FINAL PLAT
KISER WEST ADDITION
AN ADDITION TO WICHITA SEDGWICK COUNTY, KANSAS

RE: SUB 2001-74 -- One-Step Final Plat of Kiser West Addition

CASE NUMBER: SUB 2001-74 -- KISER WEST ADDITION

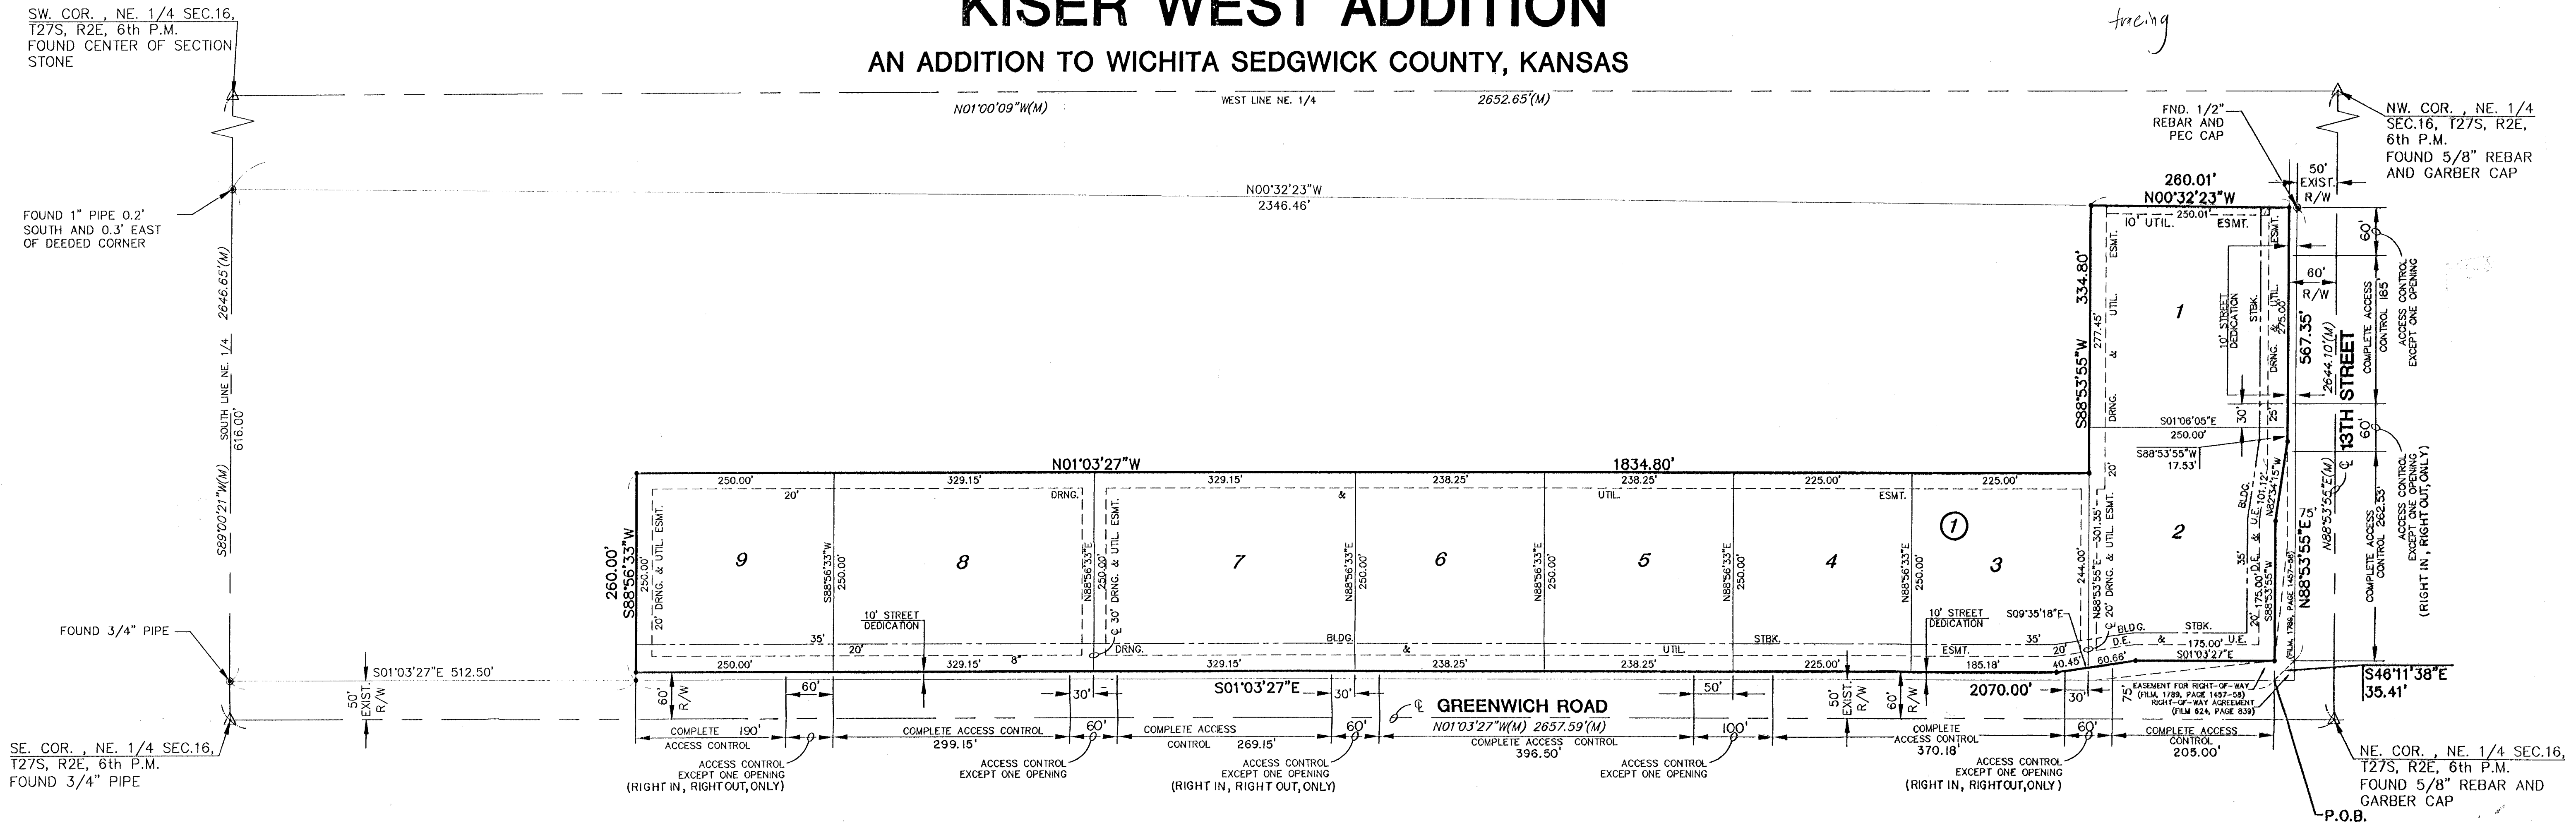
- E. The plat proposes five access openings along Greenwich and two access openings along 13th St. Distances should be shown for all segments of access control. In accordance with the CUP approval, the access openings located between lots 1 and 2, 2 and 3, and between lots 6 and 7 are limited to right-turns only, and shall be referenced on the face of the plat.

- J. On the final plat, the MAPC signature block needs to reference "J.D. Michaelis, Acting Chair".
- K. The applicant needs to revise the legal description to accurately portray the land being platted. If the platted description is different than the legal, then both descriptions shall be shown.

- L. On the north line of Lot 2, the extra "35 feet" label may be removed.
- M. The spelling of the label at the center of the section should be corrected to "Center".

- N. A dimension needs to be added on the south line of the 25-ft drainage and utility easement on the north side of Lot 1.
- O. The labeling of dimensions and dedications along 13th Street and within Lots 1 and 2 needs to be reoriented 180 degrees to be aligned with the north arrow.
